MOTOROLA

Subject: Request for additional information regarding FCC ID: IHDT56ET1 (Portable Cellular/PCS AMPS/CDMA Transceiver)

Application Received: 5/24/2004
Correspondence Reference Number: 240608A.IHD
Confirmation Number: TC4181
Date of Original Email: 06/08/04

CDMA 800 – Channel 384 (836.52 MHz) – Occupied Bandwidth

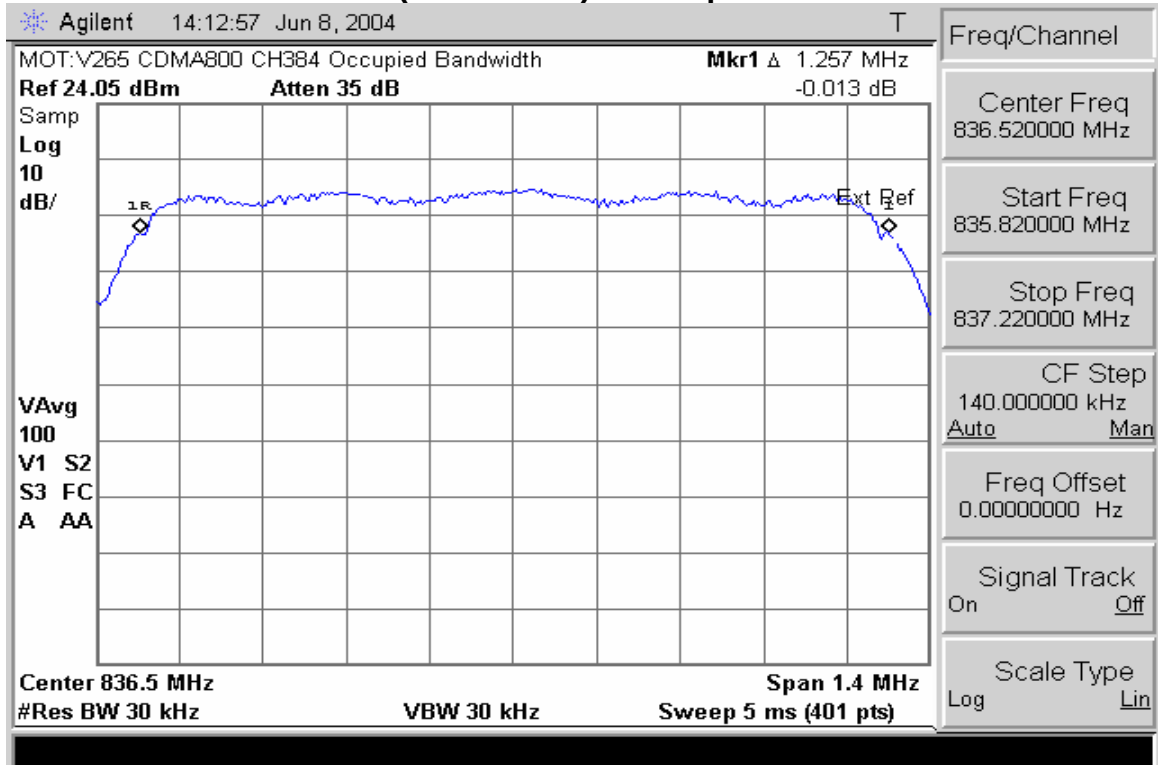
2. Please provide occupied bandwidth plots for both cellular CDMA and PCS CDMA operation.

Response: Please refer to the following plots:
